**PLANNING BOARD
-AGENDA-
BRUNSWICK TOWN HALL
85 UNION STREET
COUNCIL CHAMBERS**

**Draft Findings of Fact
Brunswick Landing Subdivision – Phase II
Major Subdivision Plan Final Review
Review Date: September 22, 2015**

Project Name: Brunswick Landing Subdivision – Phase II
Case Number: 15-020
Tax Map: Map 40, Lots 0, 29, 55, 81, 201, 221, 226 (as submitted)
Map 40, Lots 55 and 81 (as reviewed by staff)
Zoning District: BNAS Reuse District; Land Use District Business and Technology Industries (R-B&TI)
Applicant: Midcoast Regional Redevelopment Authority
15 Terminal Road, Suite 200
Brunswick, Maine 04011
207-798-6512
Authorized Representative: Wright-Pierce
99 Main Street
Topsham, ME 04086
207-725-8721

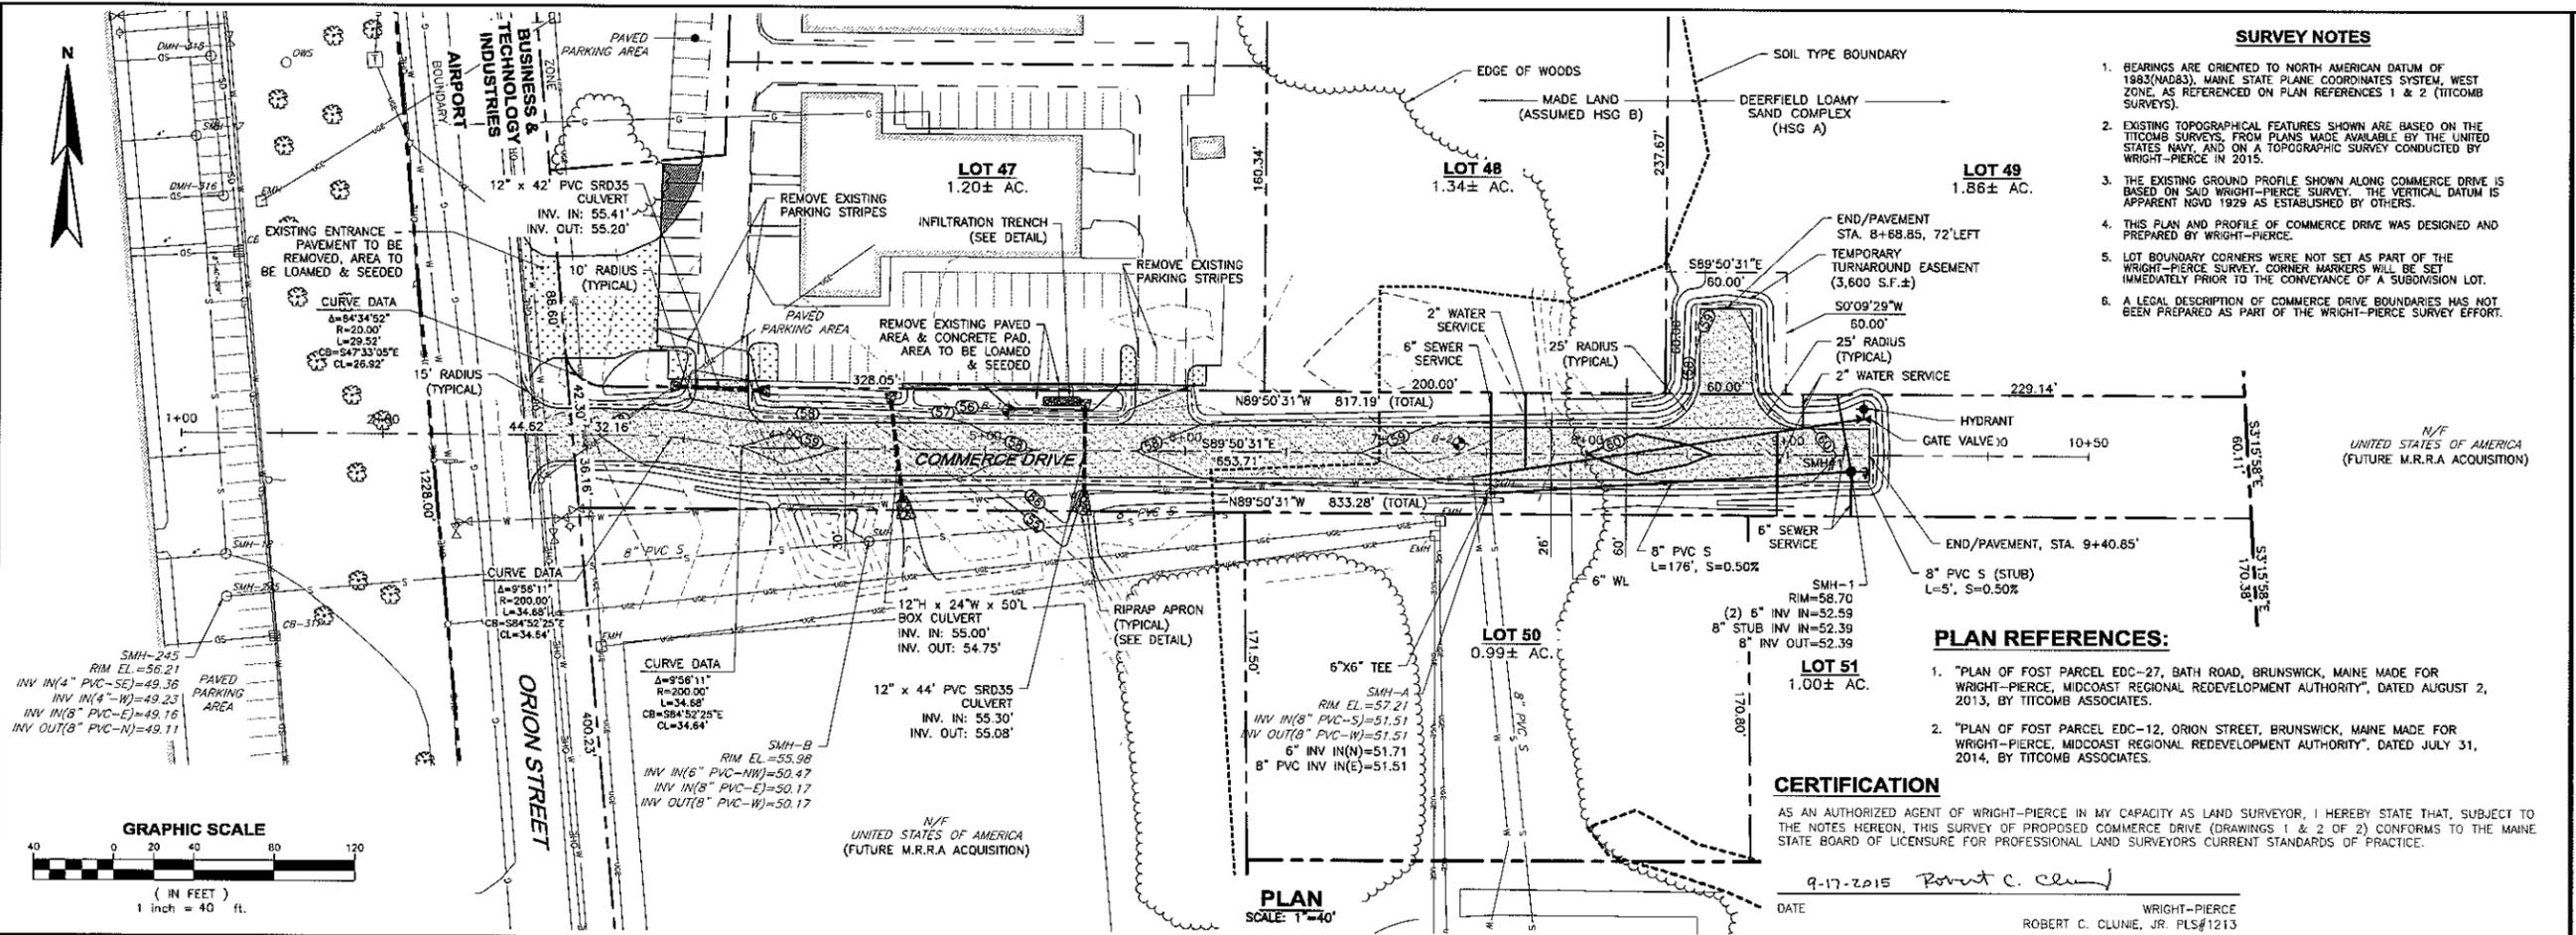
Jeff and/or Ken: Do you approve of the revised hydrant location and fill extension on Commerce Drive (Brunswick Landing Subdivision Phase II)? If not, I need to contact the applicant as soon as possible because the findings for the planning board need to be drafted by this Friday. I can provide more information if you need it. Thanks for your time!

Here is a detail of the end of the road with the revised grading to accommodate the hydrant. Let me know if you have any other questions.
